PETITION FOR SPECIAL HEARING

We, GLAUBER'S FINE CANDIES, hereby petition for a special hearing under Section 500.7 of the Zoning Regulations of Baltimore County, to determine whether or not the Zoning Commissioner and/or Deputy Zoning Commissioner interpret Section 104.1 for existing non-conforming use to determine whether or not the permitted 25% extension can be applied to floors other than the ground floor area.

GLAUBER'S FINE CANDIES, Petitioner : Case No. 81-137-SPH

Petition for Special Hearing
North side of Register Avenue, 125 feet West of Sharon Road
Petitioner- Glauber's Fine Candies

SITE PLAN FOR SPECIAL HEARING REQUEST

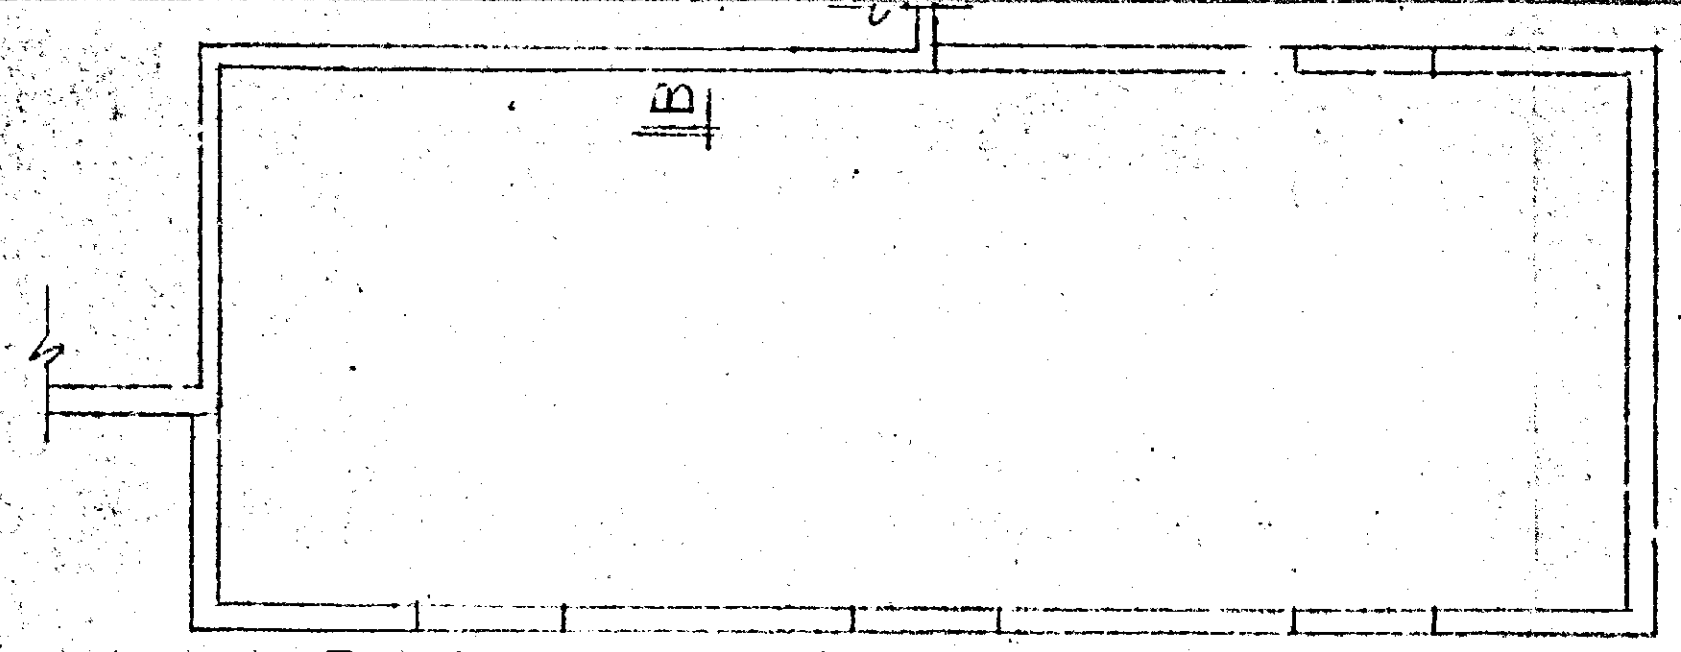
Provisions for accommodating storm water or drainage have not been indicated on the submitted plan.

If the petition is granted, the addition should be residential in character and the parking area screened from adjacent residential properties.

4. All on-site parking shall comply with the requirements of Section 409.2.c(1), (2), (3), and (4) of the Baltimore County Zoning Regulations.
5. A revised site plan, incorporating the restrictions set forth above and reducing the dimensions of the proposed addition to the extent that the extension of the area of the nonconforming use is limited to 428 square feet on the "Foundation and Floor Plan" and 428 square feet on the "Second Floor Plan", shall be submitted for approval by the Department of Public Works and the Office of Planning and Zoning.

SECOND FLOOR PLAN 3/6

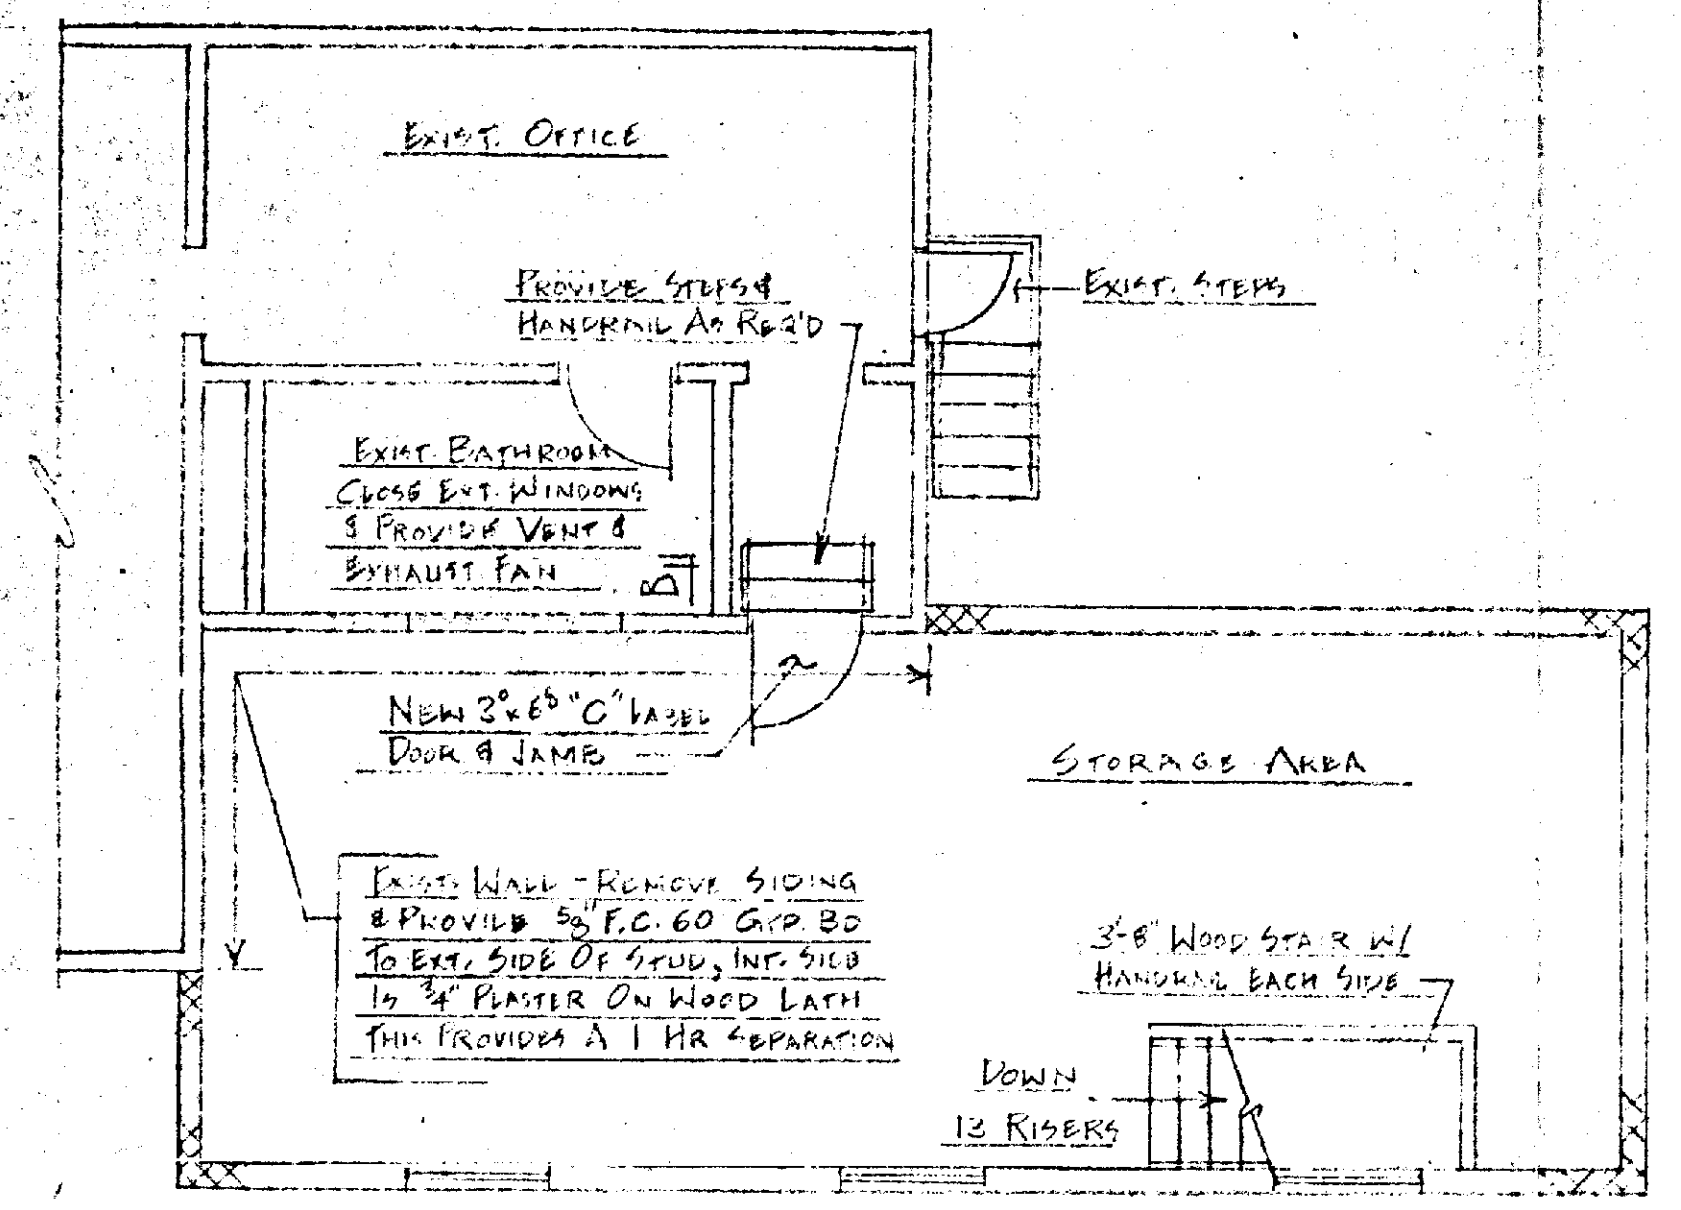
7. The proposed addition consists of an extension of the basement area and the first floor of the existing building, as noted on Petitioner's Exhibit 2 as "Foundation and Floor Plan" and "Second Floor Plan", and is proposed to contain 561 square feet of expanded area on each of the two floors for a total of 1,122 square feet.

IT IS ORDERED by the Zoning Commissioner of Baltimore County, this 21st day of April, 1981, that the extension of the nonconforming use by 428 feet (25% of 1,712 square feet) of the building (residence) so used should be and the same is GRANTED and shall be applicable to both the basement and the first floor, but shall be limited as to height, as shown on Petitioner's Exhibits 1 and 2, from and after the date of this Order, subject, however, to the following restrictions:
